**Refuse Collection Vehicle Parking Site  
Ubico Downs Road Depot  
Units F & G, Supergas Industrial Estate,  
Minster Lovell, Oxfordshire, OX29 7LY**

**Planning & Transport Statement**

**May 2021, version B**

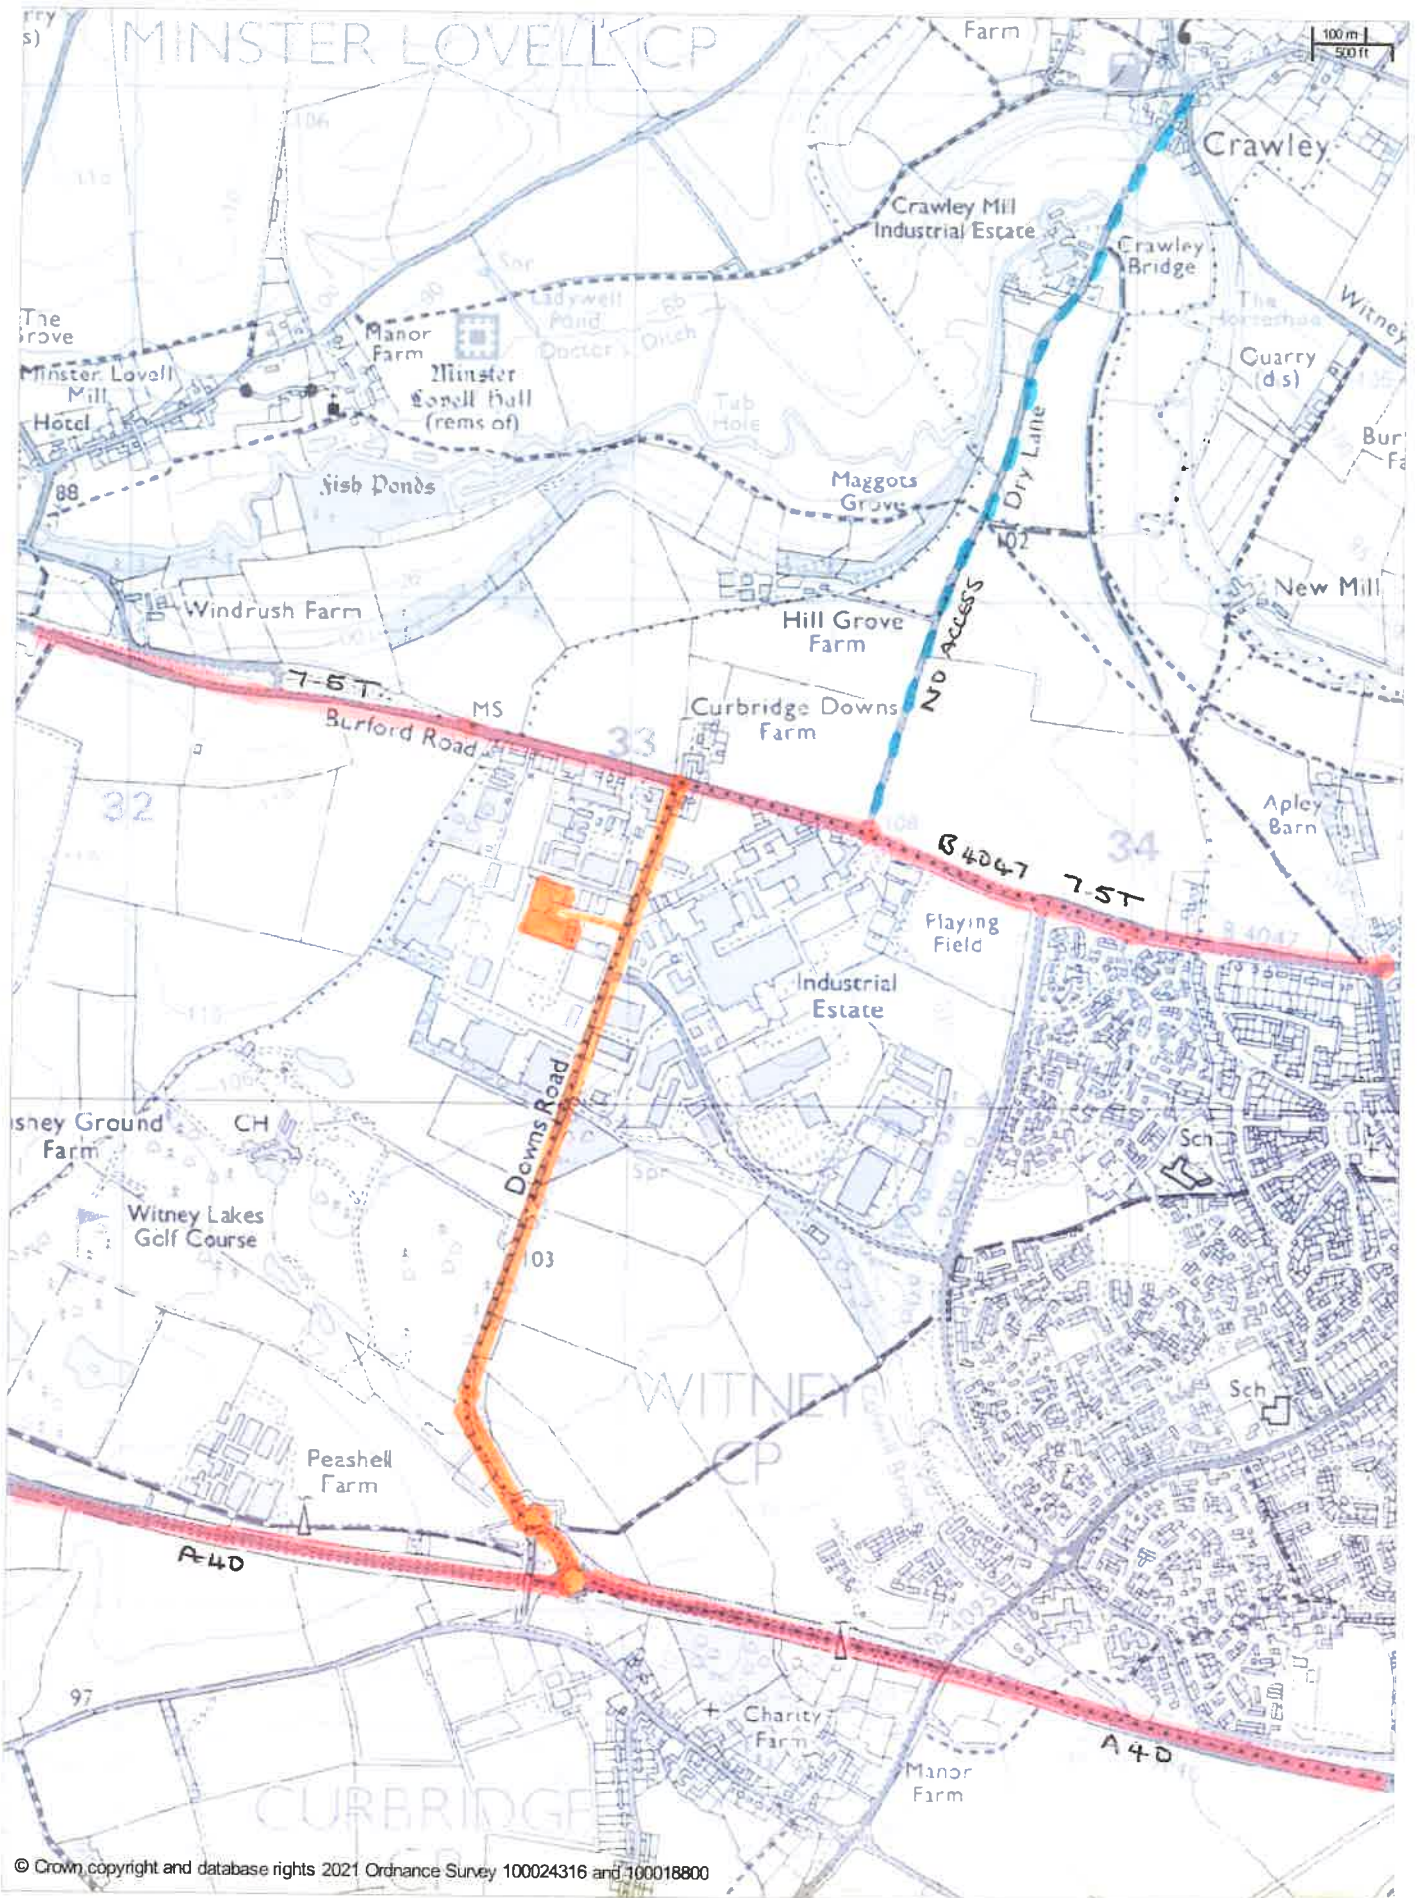
The five longitudinal spaces either side of the zebra crossing need to be 6m long to allow manoeuvring

The bays have been arranged so as to try to maximise the number of bays available for use. The following points should be taken into account when considering the suitability of the existing layout in this context:

- a. Three of the five bays are not abutted by another parking bay at both ends, and this in practice means that there is always space for vehicles to manoeuvre beyond at least one end of the bay in order to align/ park in the bay;
  - b. The bays are normally occupied in sequence, so in reality all of the bays provide more room to manoeuvre than the bay markings suggest;
-

- c. The car park users are familiar with the car park layout, and the manoeuvre into and out of the bays;
  - d. There is a wide, clear and level aisle width to allow for manoeuvre into/ out of these bays.
-

## **Marked up Approved Lorry Route Maps**

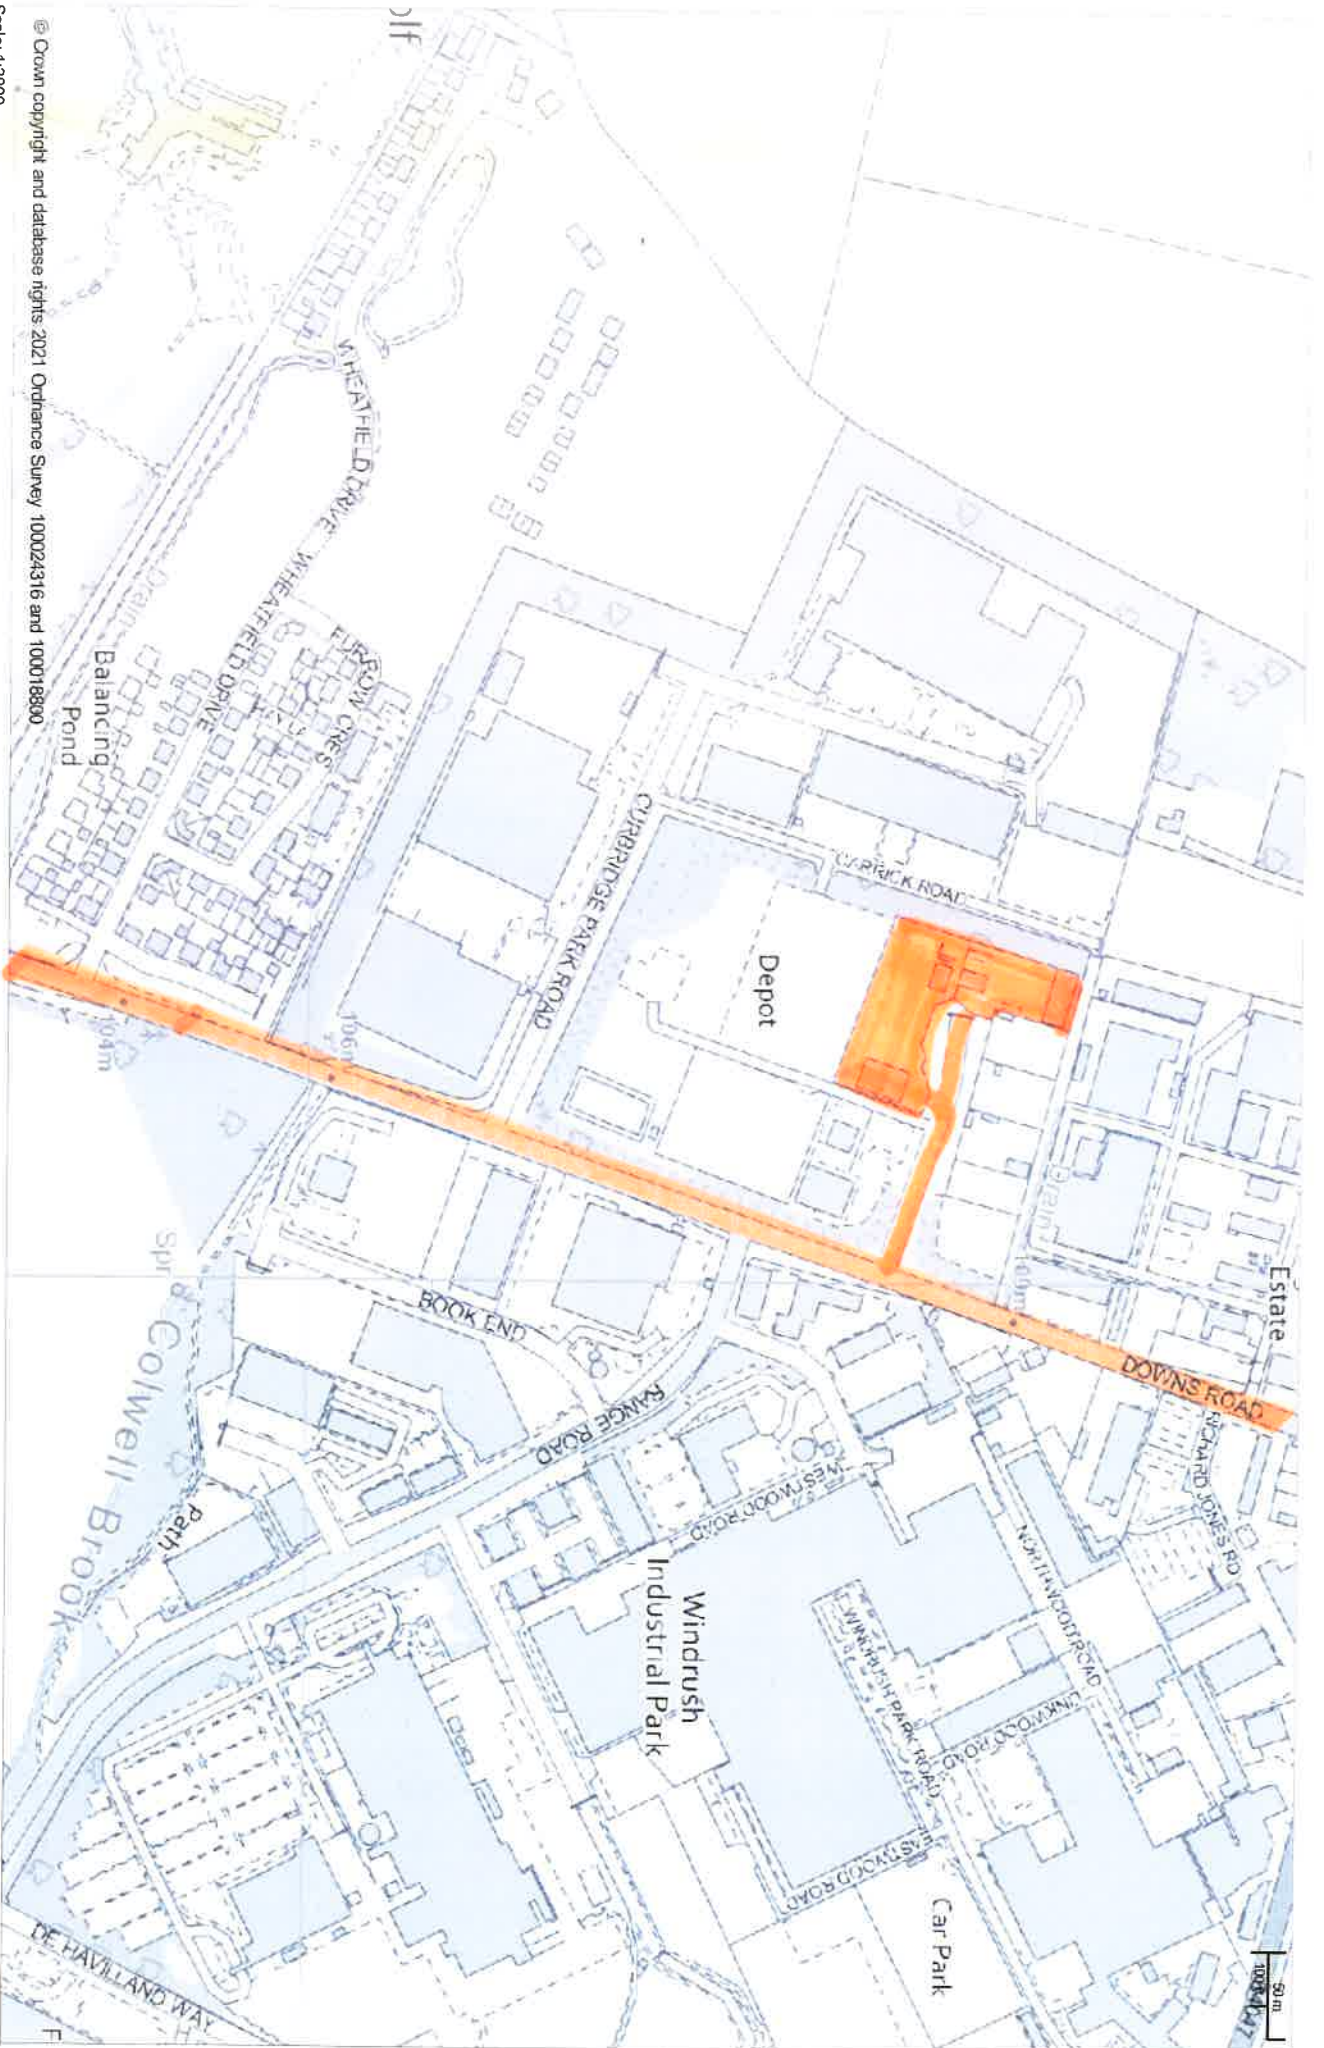
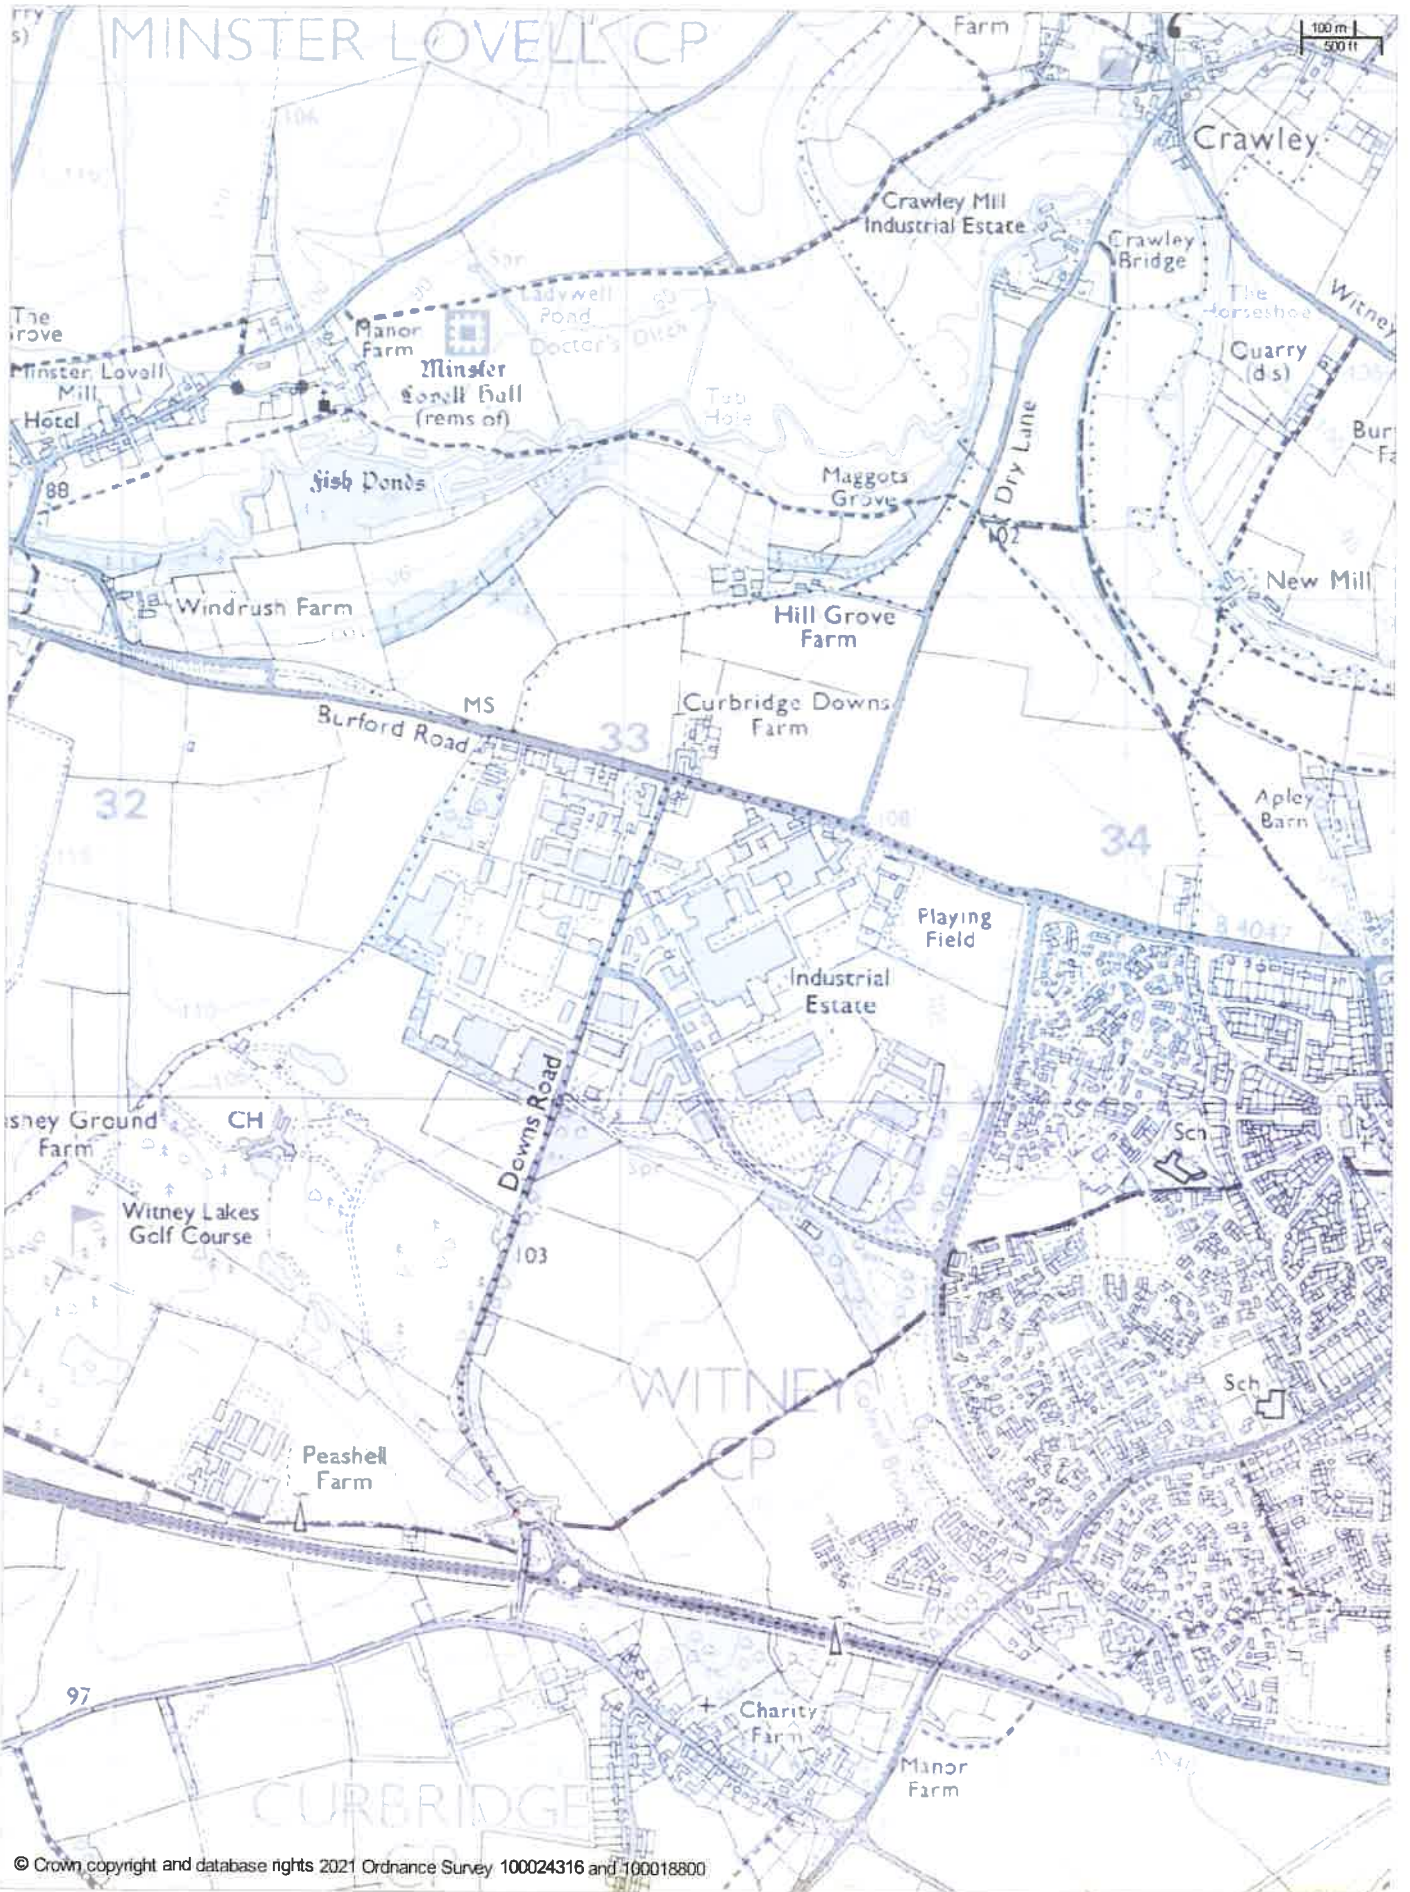
The lorry route map on p116 of the plan identifies the B4047 as a local access route, which links to the A40, which is a through route. Other roads in the area are not shown on this map and therefore any application which is submitted needs to demonstrate that safe and suitable access can be made onto those routes.

See marked up agreed lorry route maps provided at appendix A.

The extant routing agreement (11 April 2011) identifies the B4047 as a temporary route, until the new junction on the A40/ Downs Road was implemented (25 August 2018). The new weight limit of 7.5t on the B4477 and B4047 since the junction opened shouldn't impact on waste collections for residential properties, as clause 3.1.1 states that: *'to the extent necessary to enable any vehicle to deliver or collect goods relating to the developer's business or businesses to or from an address or addresses on the prohibited road'*

The road network serving this site has recently been improved by the Highway Authority with an additional interchange being constructed on the A40 East/West bound at Curbridge. This new junction provides Ubico the opportunity to avoid any through travel into Witney from the western side using the B4047. The junction promotes a fast link to the West and East via a twin lane dual carriageway, this links purposely serves all of our discharge points by design.

Ubico collection vehicles have no access to the B4047 to the north side of Downs Road, unless they are on specific day collection of household waste or refuelling at the BP garage. There are no approved routes through the villages of Crawley and Minster Lovell.
